TENANT IMPROVEMENT WORK FOR

intimissimi

SPACE #111
WESTFIELD GALLERIA AT ROSEVILLE
1151 GALLERIA BLVD,
ROSEVILLE, CA 95678

12.13.2024	LL PERMIT SET	
	DATE	REVISION

SHEET NO. **A302**

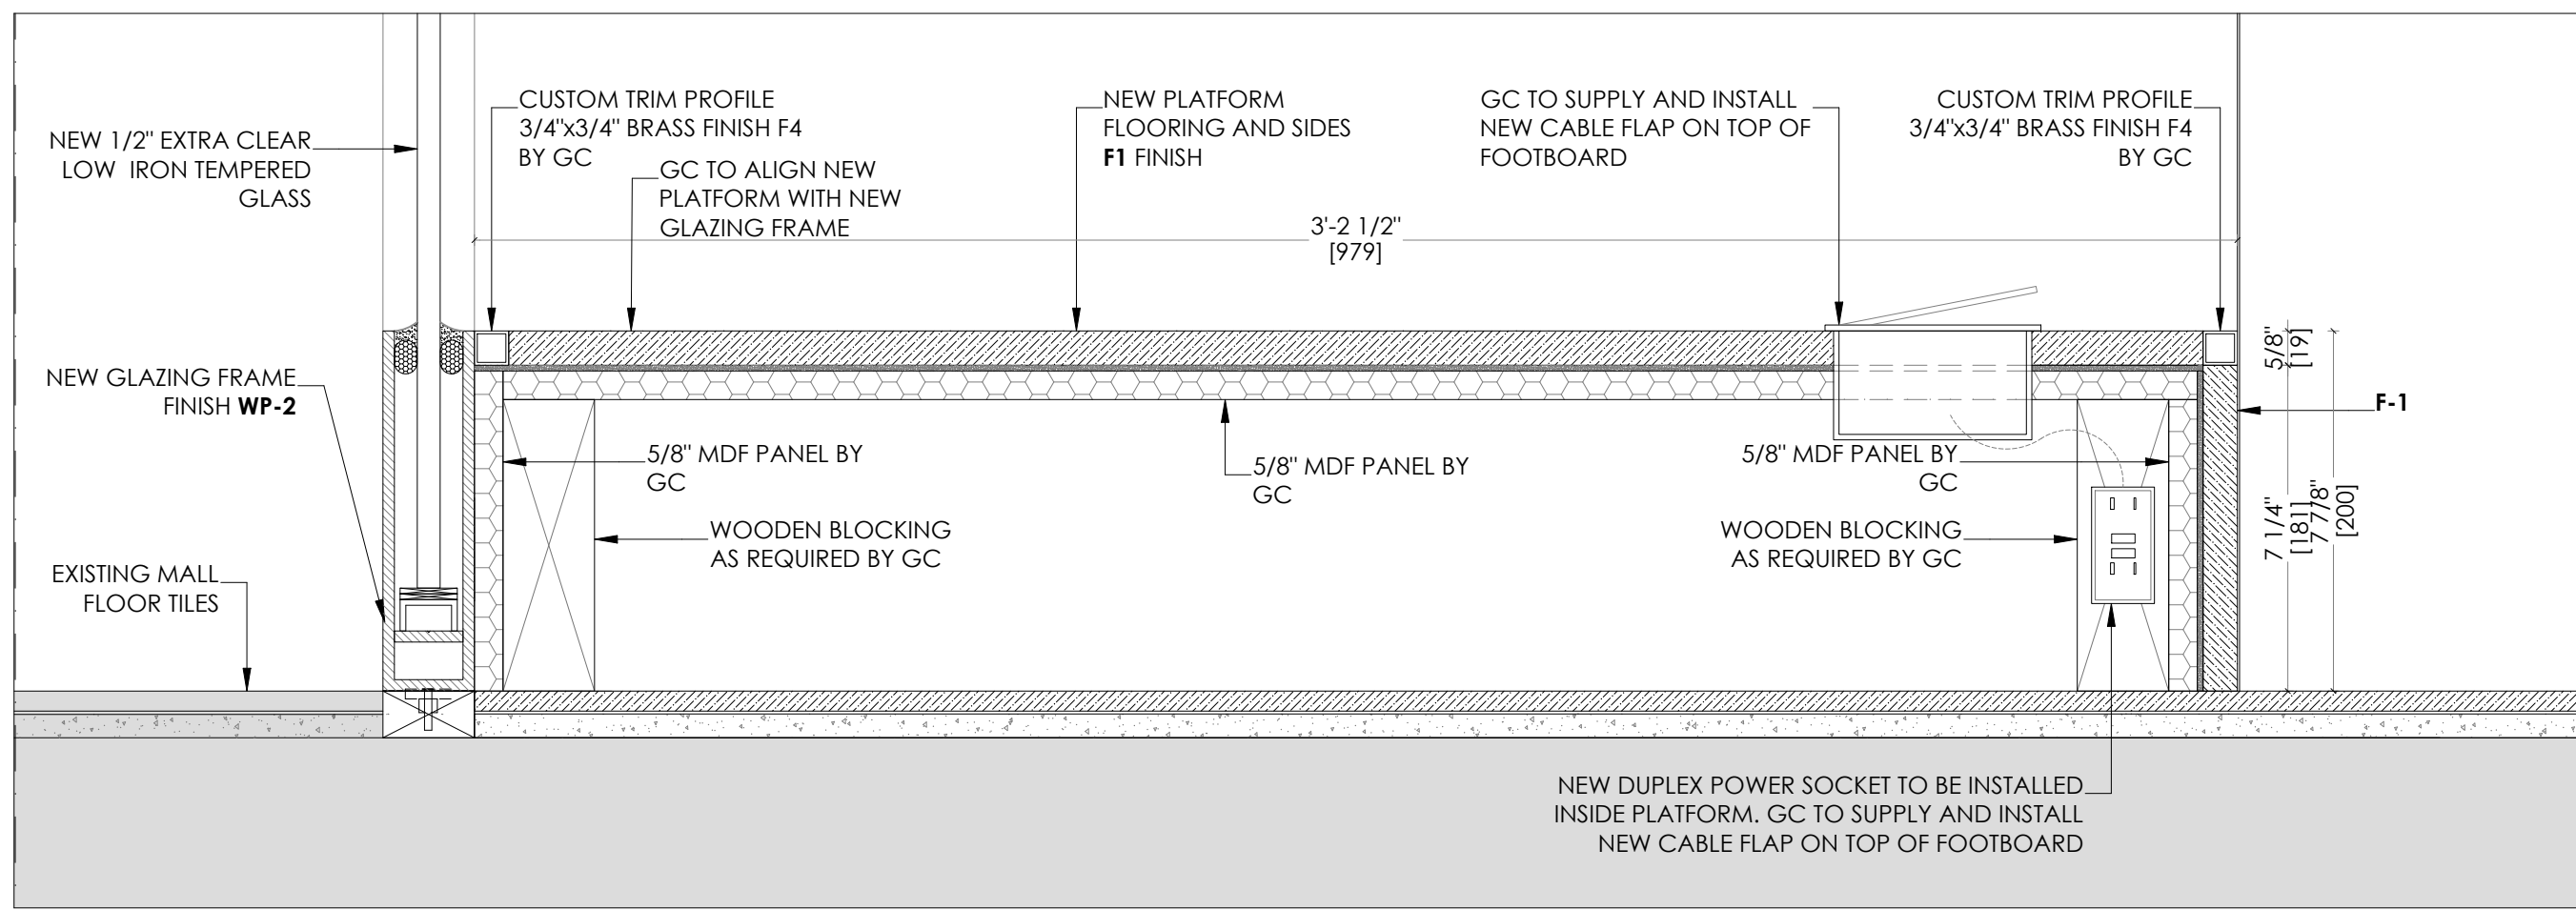
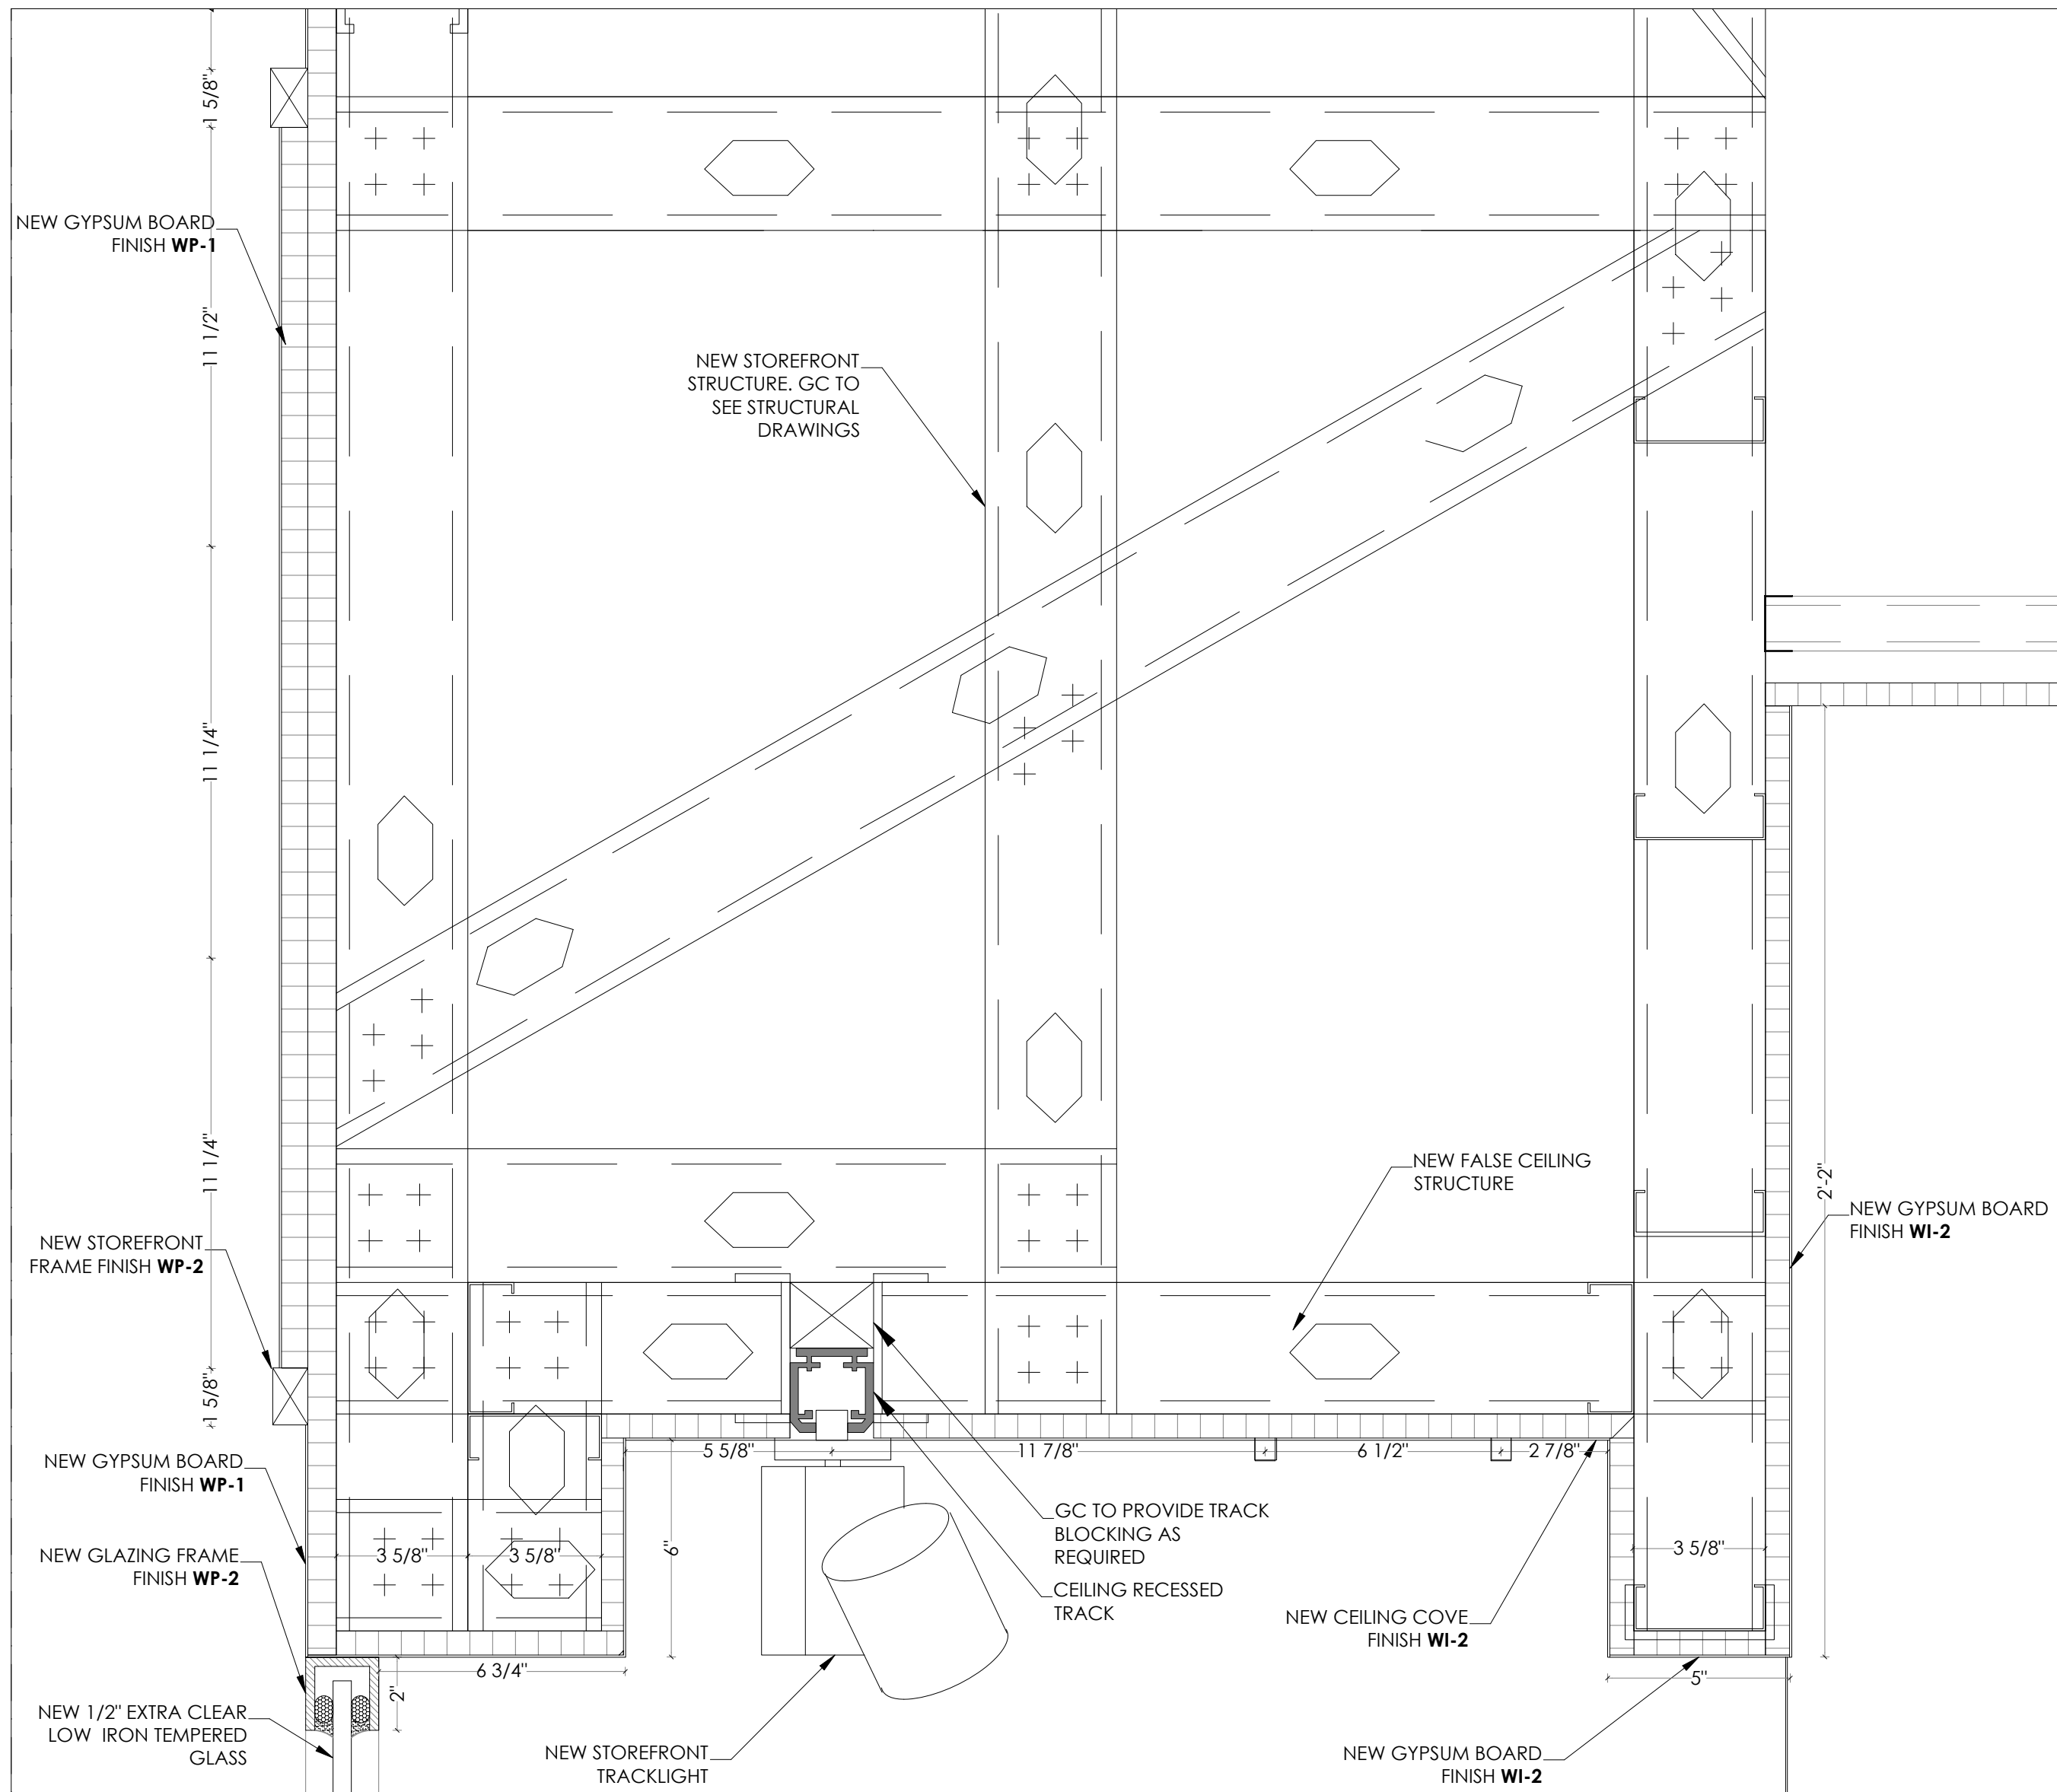
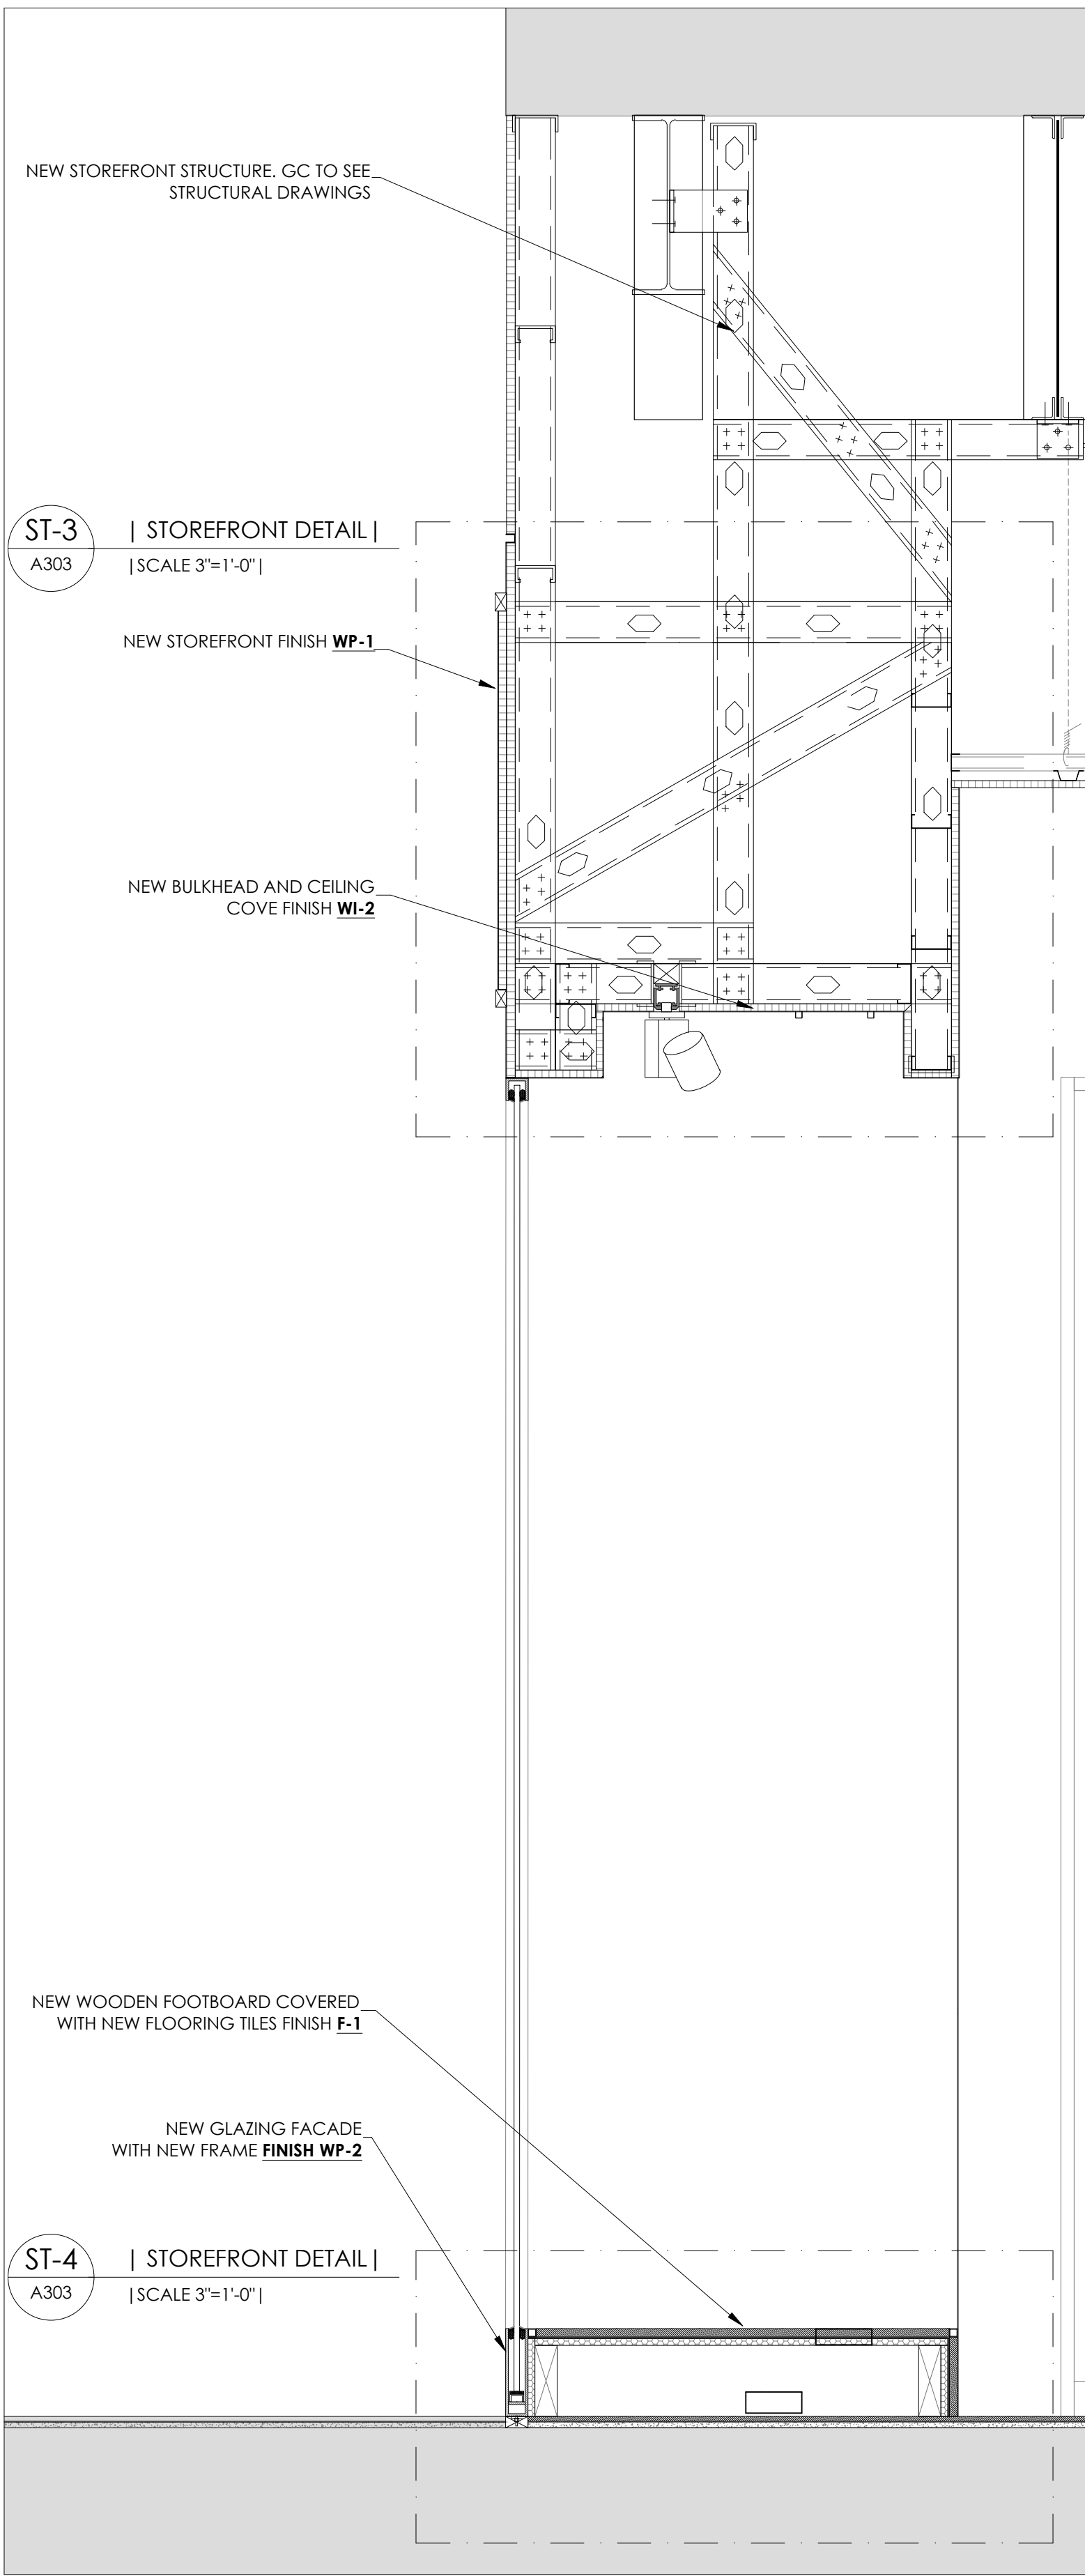
-STOREFRONT NUMBERS AND ADA SIGNAGE AFFIXED TO STOREFRONT MUST FOLLOW LL
REQUIRED SPEC. REFER TECHNICAL CRITERIA. NO OTHER DECALS MAY BE ATTACHED TO GLASS
(OPENING HOURS, PROMOTIONAL SIGNAGE ETC.) WITHOUT MALL MARKETING APPROVAL

-DOOR HEIGHT MUST BE 10' MINIMUM HIGH AS PER CRITERIA

-TENANT GC TO REINSTALL FIRE STROBE ON NEUTRAL PIER WHERE OCCURS
